## Jacuzzi<sup>®</sup> Hot Tubs Technical Bulletin <u>Change to J-400™ Diverter Nut</u>

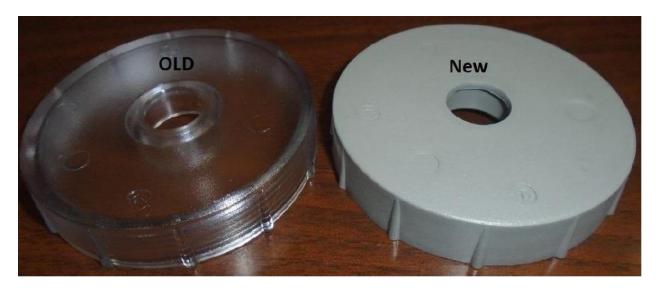
To increase reliability in the field, Jacuzzi<sup>®</sup> Hot Tubs is making a **change to the diverter nut on all J-400**<sup>™</sup> **Collection Models**. This part (**6540-455**) will be changing <u>from clear</u> Lexan material to grey glass-filled ABS material.

When ordering this part for service on spas made before September 2023, please note that the replacement parts will be a different color (grey) than the original part (clear). This does NOT indicate that you have received the wrong part. The grey part is interchangeable with the clear version. The clear version of this part will no longer be available.
